New Albany Architectural Review Board
Monday, April 13, 2026 Meeting Minutes - Approved

ARB-06-2026 Police Training Facility Certificate of Appropriateness and Waiver

ARB-24-2026 Public Service Storage Facility Certificate of Appropriateness

ARB-13-2026 W Nail Bar Signage Certificate of Appropriateness

Image: proposed location of storage structure (blue circle) and press box (red circle).

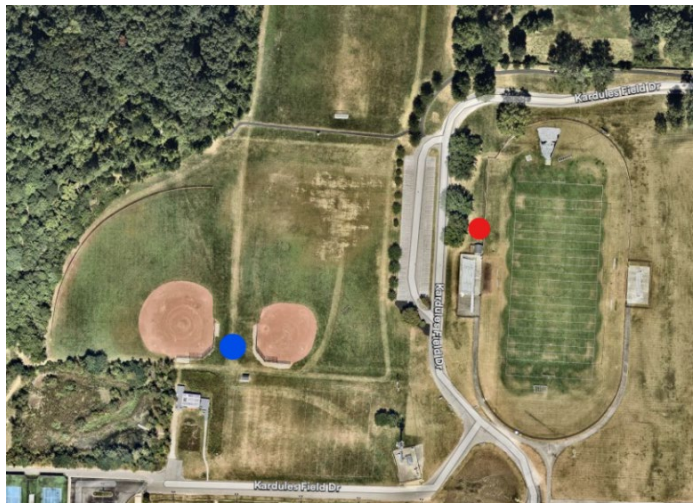
- The press box will be relocated on the north side of the existing bleachers on 6666 McElwee Drive. It stands at approximately 21.5 feet in height with a staircase on one side to provide pedestrian access to the second story.
- The press box has exterior downcast lighting over the entrances on the first and second stories.
- The storage structure will serve the two softball fields.
- While there is little to no screening of the structures from the public right-of-way along New Albany-Condit Road, because of the large setback from the road and a noticeable grade change, the structures are functionally screened from view.
